ADDENDUM

MEETING OF THE PLANNING COMMITTEE

WEDNESDAY 14th December 2022

PLANNING APPLICATION: 22/00271/F - REIGATE GRAMMAR SCHOOL REIGATE ROAD REIGATE SURREY

5 Cricket - Community/Club
Scale: 1:200

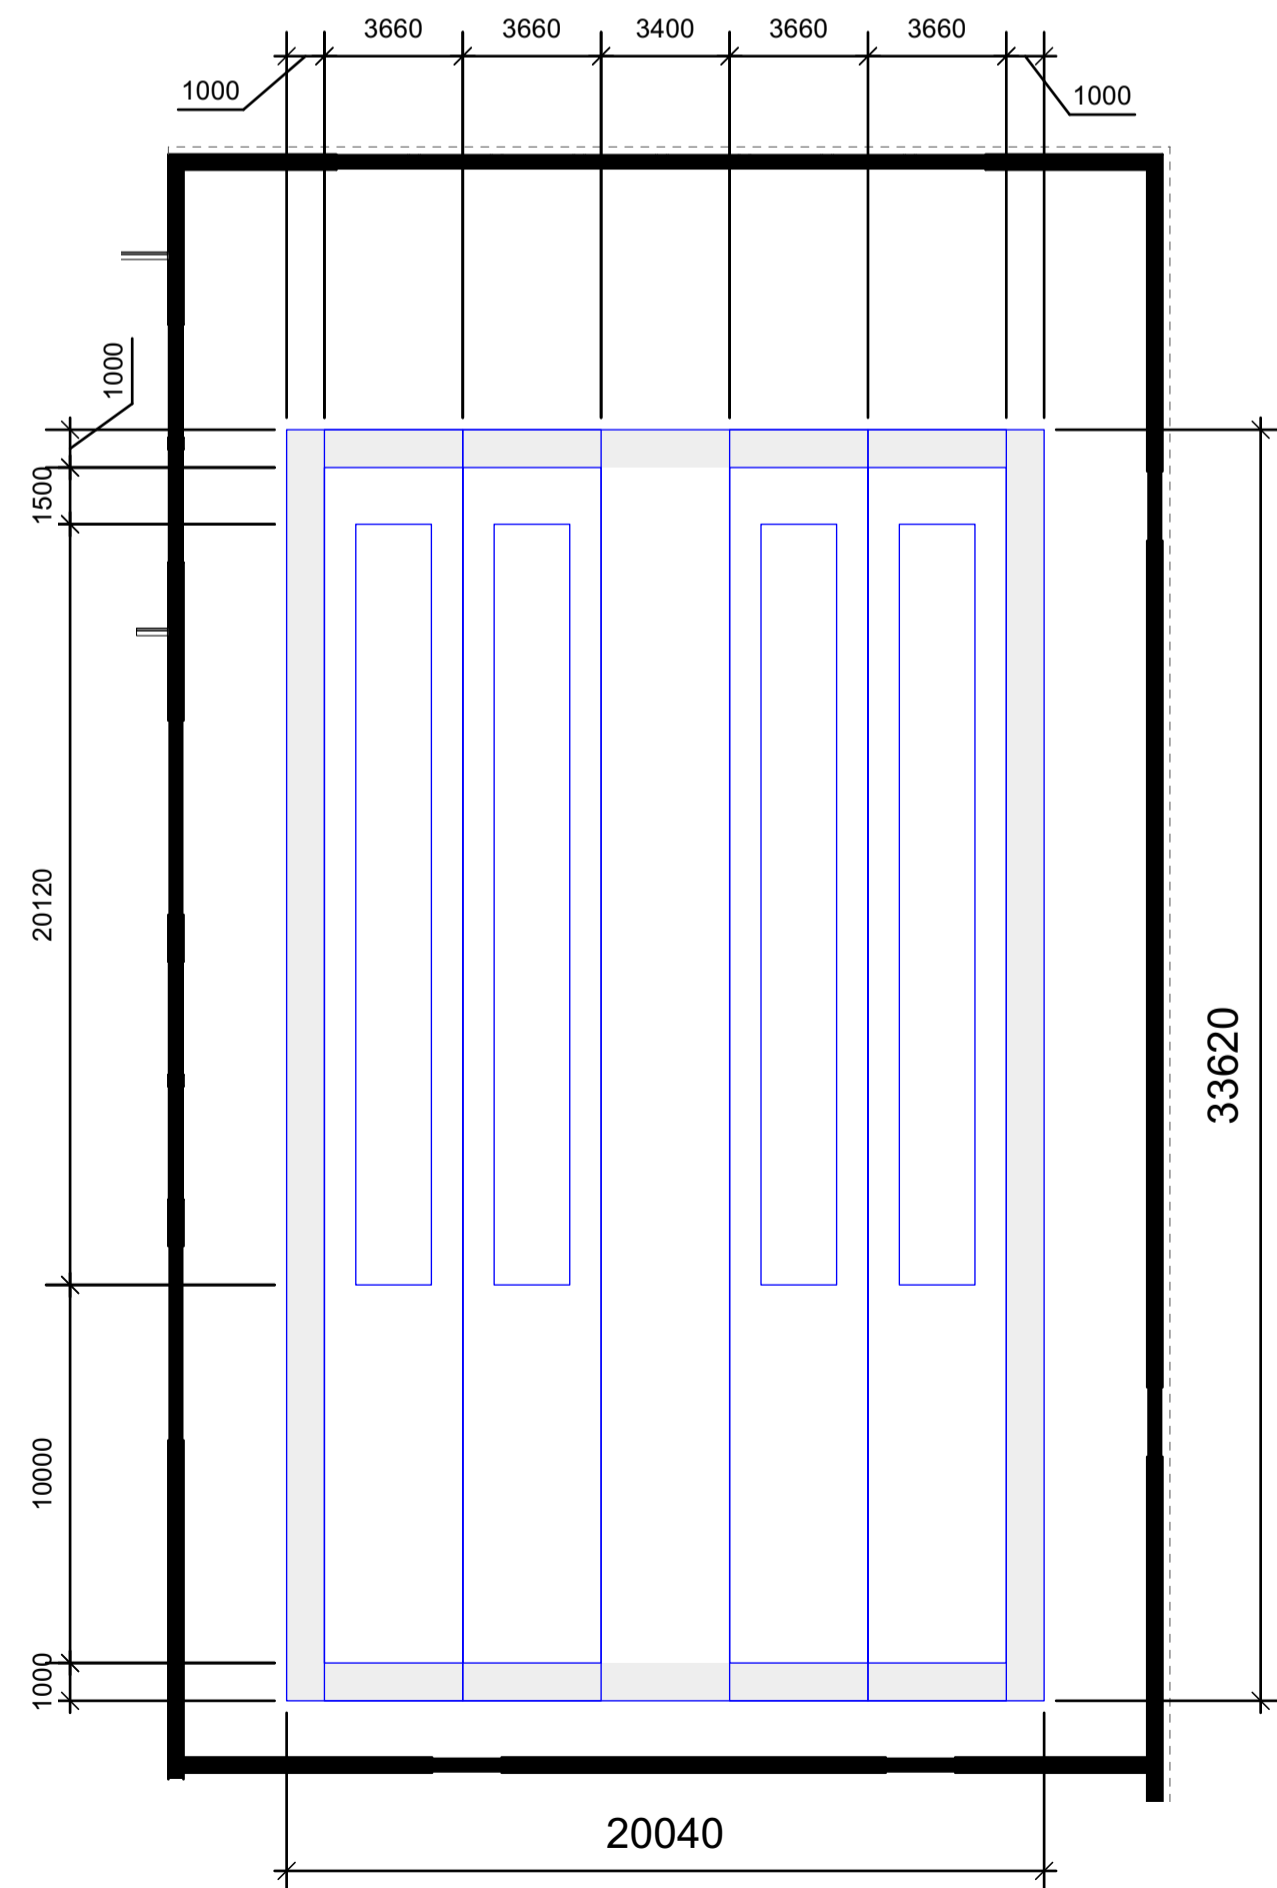
25.5m wide x 42m long x 8m high (approx. 7.7m useable). **Appendix A** shows the size of the sports hall, sized to Sports England requirements for a range of sports.

Sports hall sized to Sports England requirements for a range of sports.

Sports Hall height to be 7.7m
